Documentation of Public Meeting

Loop 340

2362-01-034 and 0258-09-143

Loop 340 Public Meeting - August 24, 2017 - Comment Response Matrix

ROLL 3 OF 8

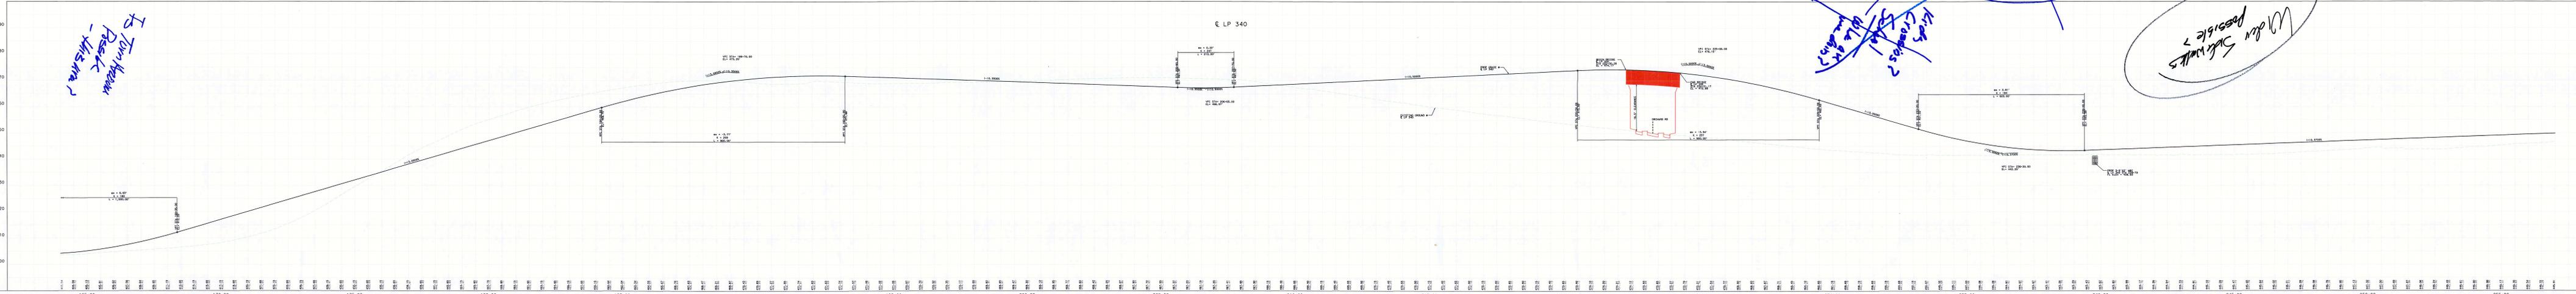
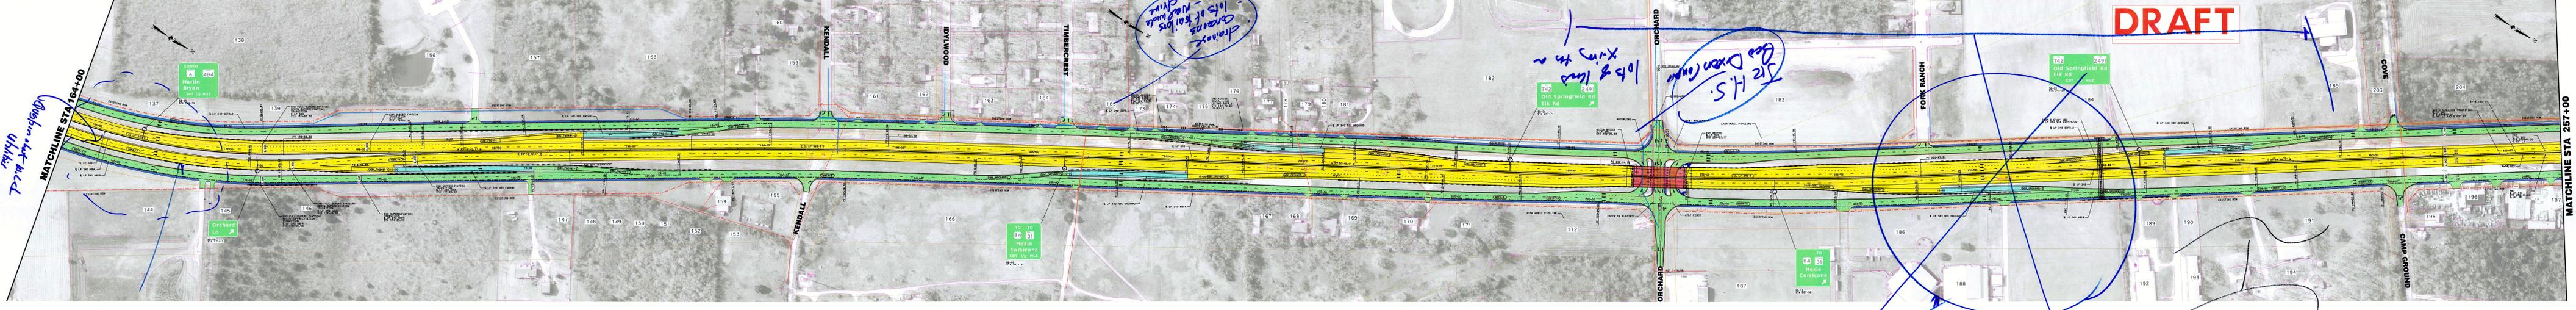
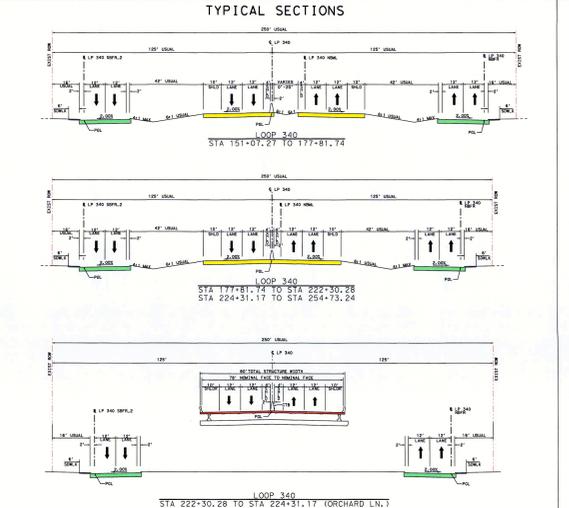
| Comment Number | Commenter Name | Date Received | Source | Comment | Response |
|---|----------------|---------------|-------------------------------------|---|--|
| 2 | | 8/24/17 | Comment written on schematic roll 3 | Question about local utilities | Comment noted. |
| 3 | | 8/24/17 | Comment written on schematic roll 3 | Is turn around possible - this area? | Proposed u-turns are provided at FM 2491 and Orchard Lane. The proposed freeway design speed and topography limits the ability to provide a u-turn at this location. |
| 4 | | 8/24/17 | Comment written on schematic roll 3 | drainage concerns - lots of trailers - need wide drive | <p>A proposed driveway matching the width of the existing drive will be included in the design.</p> <p>Drainage from the proposed facility would be contained within a storm sewer system and would not drain onto property.</p> |
| 5 | | 8/24/17 | Comment written on schematic roll 3 | Is it possible to widen the sidewalks | A standard width sidewalk of 6 feet adjacent to the curb would be provided to allow the design to fit within the existing right-of-way (ROW). |
| 6 | | 8/24/17 | Comment written on schematic roll 3 | There are lots of kids that cross Loop 340 to access the JR High school | Pedestrian crossings would be provided at Orchard Street. The proposed facility provides an overpass at Orchard Street for the Loop 340 mainlane traffic. This grade separation would facilitate safe movement of pedestrians. Sidewalks adjacent to the proposed frontage roads/Orchard along with raised medians, curb ramps, and cross walks would allow pedestrian access east/west of Loop 340 and to La Vega Jr. High School |

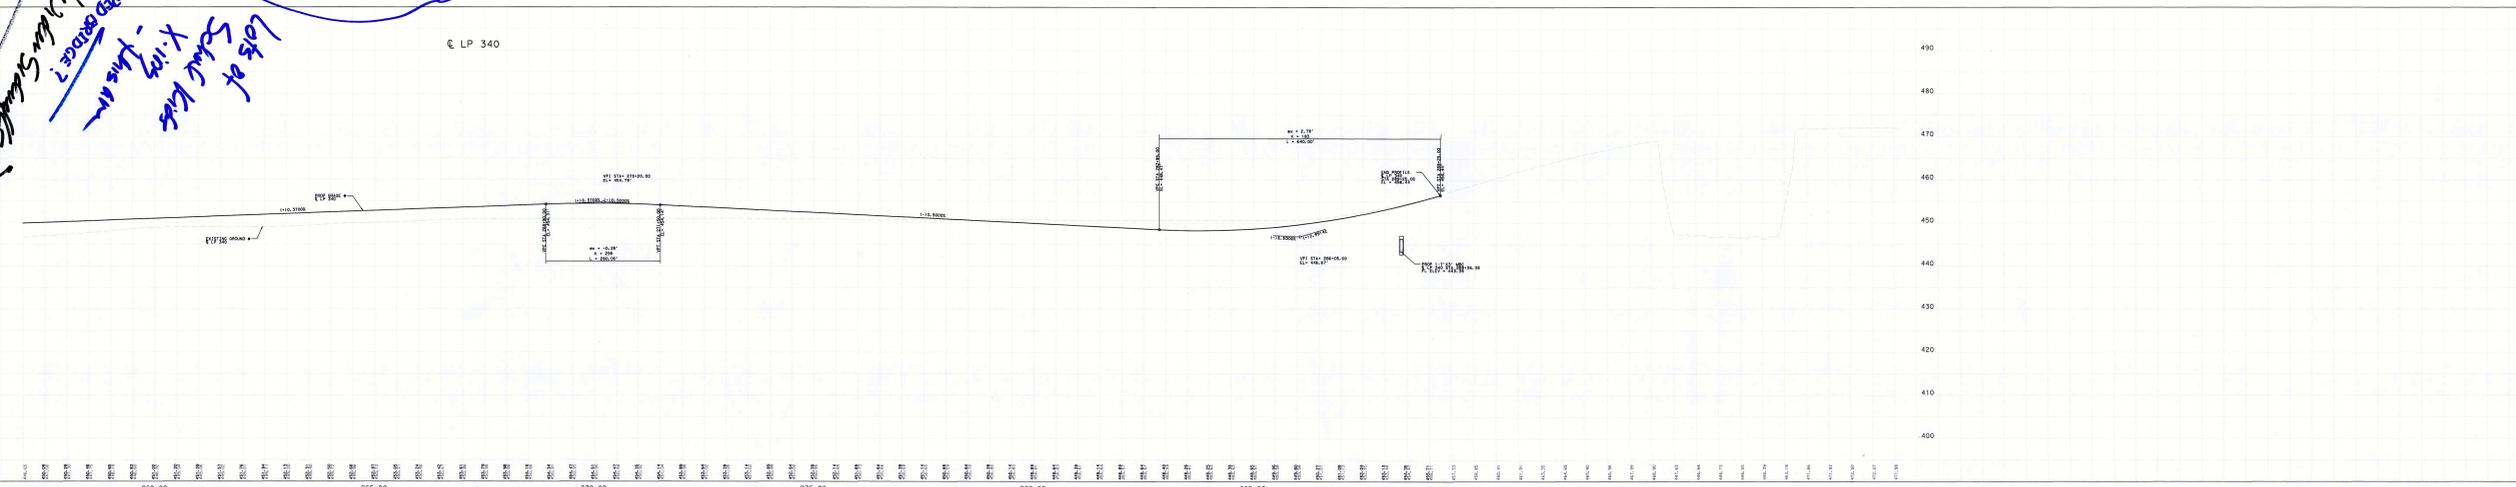
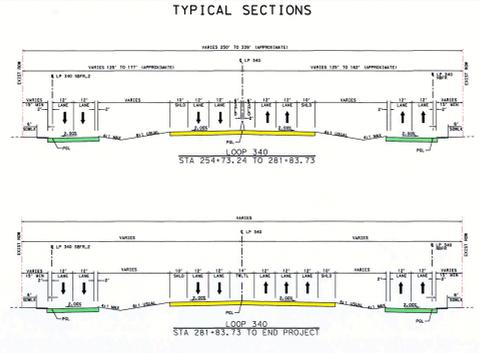
| Comment Number | Commenter Name | Date Received | Source | Comment | Response |
|---|----------------|---------------|-------------------------------------|---|--|
| 7 | | 8/24/17 | Comment written on schematic roll 4 | Lots of school kids xing this area - PED Bridge? - widen sidewalks? | <p>The feasibility of providing a pedestrian bridge has been studied with a preliminary design developed. Further review and refinement of this design will be required during the development of future construction plans.</p> <p>A standard width sidewalk of 6' adjacent to curb has been provided for the corridor to allow the design to fit within the existing ROW.</p> |

Handwritten notes:
Lots of School Kids - Home are
X-ing - Home are
Red orange - Home are
William Williams
William Williams
